## **Submission to Public Inquiry by Michael Francis**

Writing as a professional engineer, a Fellow of the Institution of Civil Engineers, with more than 40 years' experience designing and building tunnels and utility projects, I am astounded at the engineering planning of Esso's pipeline. The approach has been to define the scheme in such a way as to provide the maximum amount of choice to the contractor. There has apparently been very little consideration of different options, no considerations of value apart from cost to Esso in the area of Queen Elizabeth Park. I say this because there are a few changes to the scheme which would reduce the impact on the park. Some may increase project costs, but compared with the loss of amenity and damage to the environment, they would be insignificant; and some changes could bring cost and programme changes.

Figure 1

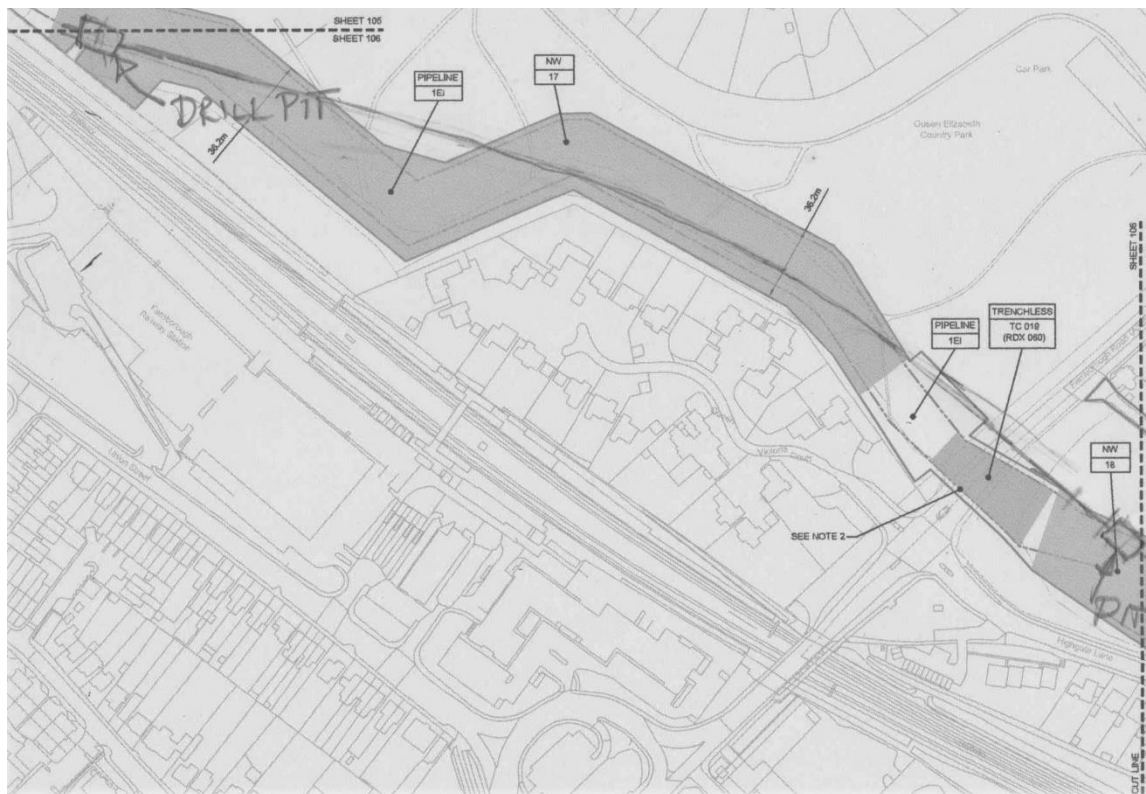
Esso in their recent response to queries about use of trenchless methods have apparently dismissed the possibility of trenchless methods after somewhat cursory analysis.

It is my opinion that there is a very feasible and attractive option to install the pipeline across the park by directional drilling. The drilling machine would be installed at the west end of the park, and the pipe string assembled on the Farnborough Hill School playing field before it is pulled through the bore. The directional drill would stretch from the west end of the park and across the A325 into Farnborough Hill School playing fields. This length is quite feasible with curvatures of 600m and is similar to other lengths of HDD bore elsewhere on the project. See Figure 1 below.

This option has huge advantages:

- There is no need to destroy large numbers of trees
- There will be no need for construction traffic to cross the park
- The amount of spoil to be removed is minimised
- Programme for the work is minimised – maybe as little as 6 weeks

- No need of the auger bore at a larger size to install pipe across the A325 saving huge cost and programme
- Reduced number of bends
- Utilises HDD plant used elsewhere on the project with reduced mobilisation cost
- Carbon cost is minimised
- Capital cost when considering all the site clearance and programme may actually be less than the construction method currently proposed.

Esso must be required to carry out detailed feasibility of this or other trenchless methods that minimise impact on the park and present these studies to inform option selection.

Considering the huge social and environmental cost of destroying trees and the park environment Esso should be required to employ trenchless methods to cross the park.
